SUBJECT: DRESDEN NUCLEAR POWER STATION, UNITS 2 AND 3 – STAFF  
ASSESSMENT OF FLOOD HAZARD INTEGRATED ASSESSMENT  
(CAC NOS. MG0221 AND MG0222; EPID L-2017-JLD-0050)

STAFF ASSESSMENT BY THE OFFICE OF NUCLEAR REACTOR REGULATION  
RELATED TO THE INTEGRATED ASSESSMENT  
FOR DRESDEN NUCLEAR POWER STATION, UNITS 2 AND 3  
AS A RESULT OF THE REEVALUATED FLOODING HAZARD  
NEAR-TERM TASK FORCE RECOMMENDATION 2.1 - FLOODING  
CAC NOS. MG0221 AND MG0222, EPID L-2017-JLD-0050

Figure 3.3.5-1 Rating Curves at the Dresden Site.

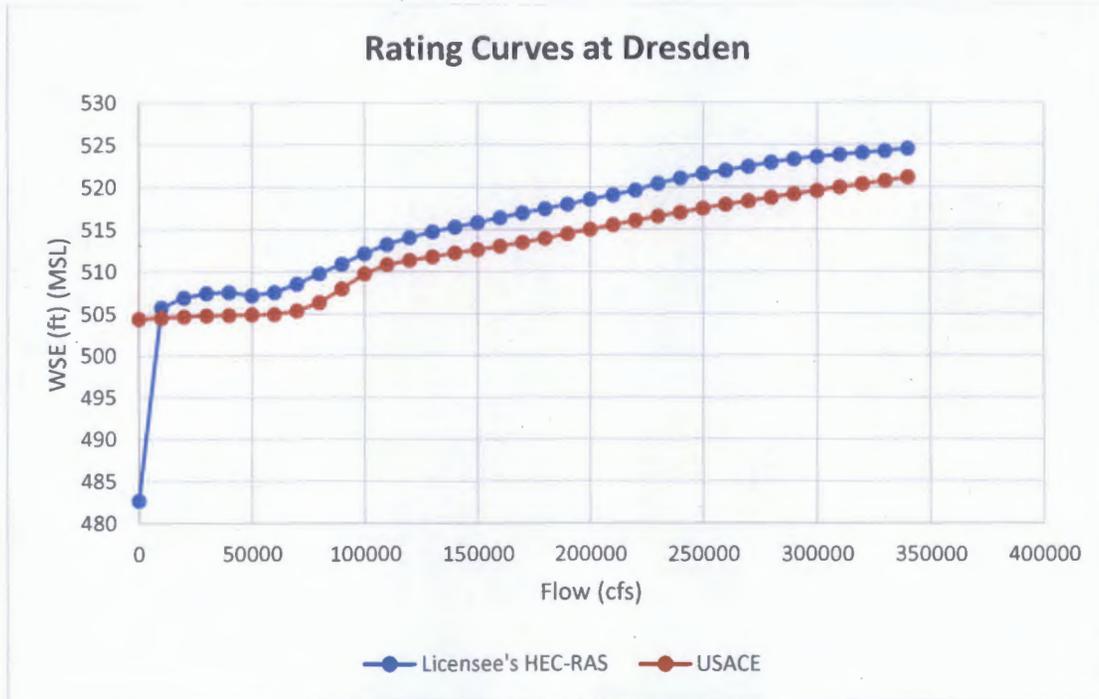
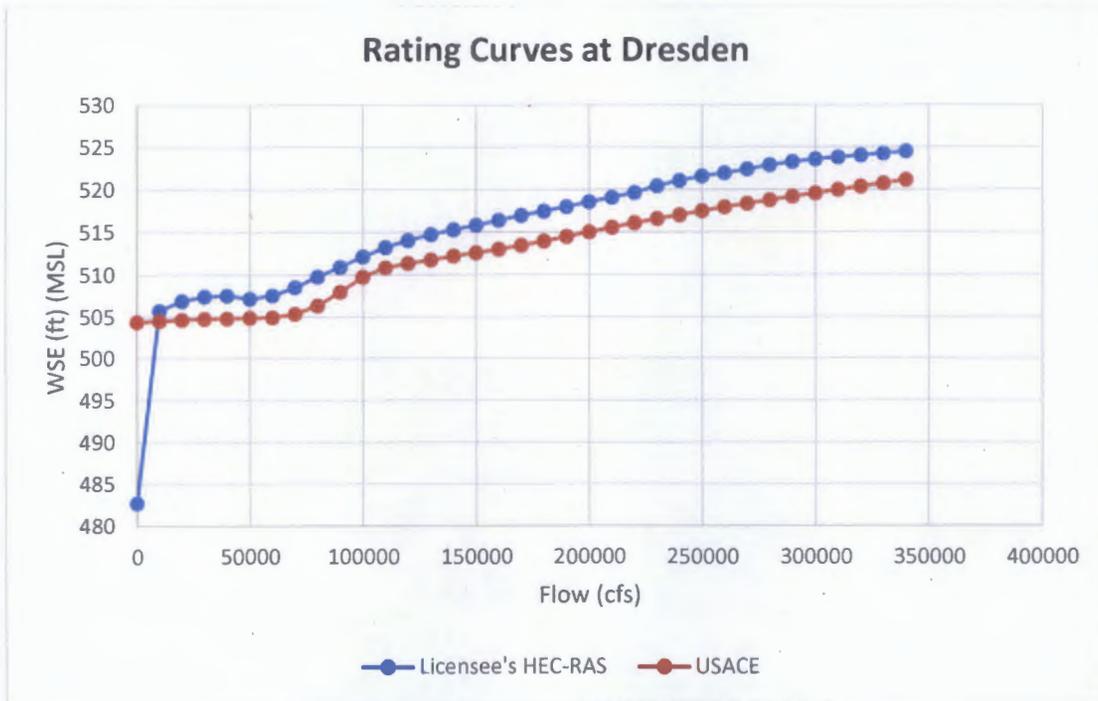
The staff generated a rating curve using the licensee's HEC-RAS model and compared this curve to the rating curve from flood frequency studies performed by the USACE for the region<sup>4</sup>. The NRC staff found the curve generated from the licensee's HEC-RAS model to be appropriate for use in the staff's independent analysis. The NRC staff used flow rates from the modified HEC-HMS models along with this rating curve to estimate the flood elevations for each scenario (Figure 3.3.5-1).

Scenario 4 is derived from a more realistic set of input parameter values and, as such, provides a better estimate of the 1E-3 annual exceedance probability (AEP) flood elevation. The staff used Scenario 5 to estimate the 1E-3 annual exceedance probability (AEP) flood elevation plus a factor, which is a surrogate for the 1E-4 AEP flood. Based on the results of Scenarios 4 and 5, the range expected for the stillwater flood elevation is between 516 ft. to 519 ft. MSL.
